# Access Compliance Report

## Public Rights-of-Way

### (Curb Ramps)

Intersection ID: 5967	Main Street: N_TRYON_ST	Cross Street: MCCULLOUGH_DR	Location: SE
ADA ID: F9F6C73D79E7	Ramp Type: BlendTrans1	Initial Pass/Fail: Fail	Overall Compliance: No
		Severity Score: 12.5

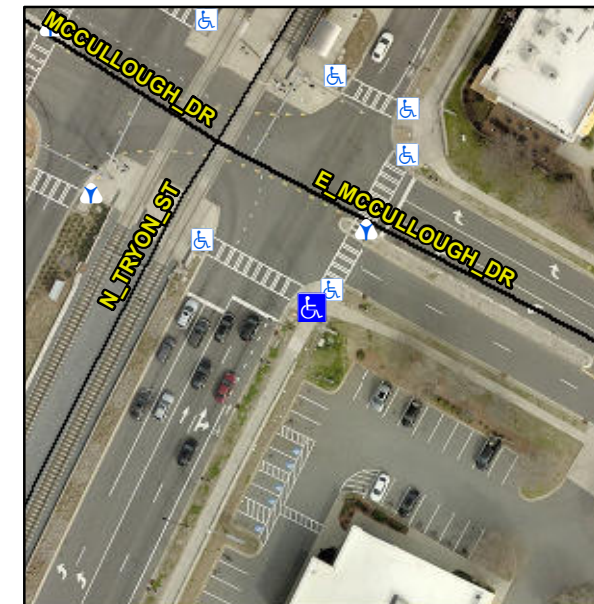
Compliance	Description	Data	Compliance	Description	Data
N/A	Ramp Length (in)	94.5	Yes	BlendTrans Slope (%)	1.5
Yes	Ramp Width (in)	48.0	No	BlendTrans XSlope (%)	5.3
N/A	Flare Type LT	N/A	N/A	Flare Type RT	N/A
N/A	Flare Slope LT (%)	N/A	N/A	Flare Slope RT (%)	N/A
N/A	Flare Traversable LT?	N/A	N/A	Flare Traversable RT?	N/A
N/A	Landing Length (in)	N/A	N/A	DWS Provided?	N/A
N/A	Landing Width (in)	N/A	N/A	DWS Contrast?	N/A
N/A	Landing Slope (%)	N/A	N/A	DWS Length (in)	N/A
N/A	Landing X Slope (%)	N/A	N/A	DWS Full Width?	N/A
N/A	Landing Curb? (Y/N)	N/A	N/A	DWS Offset (in)	N/A
N/A	Shared Landing?	N/A			
N/A	Gutter Ponding?	N/A	N/A	Gutter Slope (%)	N/A
N/A	Gutter Lip Ht (in)	2.0	N/A	Gutter X Slope (%)	N/A
N/A	Painted X Walk1?	No	N/A	Painted X Walk2?	N/A
	X Walk 1 Direction	To NW		X Walk 2 Direction	N/A
	X Walk 1 Width (in)	N/A		X Walk 2 Width (in)	N/A
	X Walk 1 Slope (%)	2.3		X Walk 2 Slope (%)	N/A
	X Walk 1 X Slope (%)	1.3		X Walk 2 X Slope (%)	N/A

**Remove & Replace Curb Ramp With Two New Directional Ramps or Equivalent.**
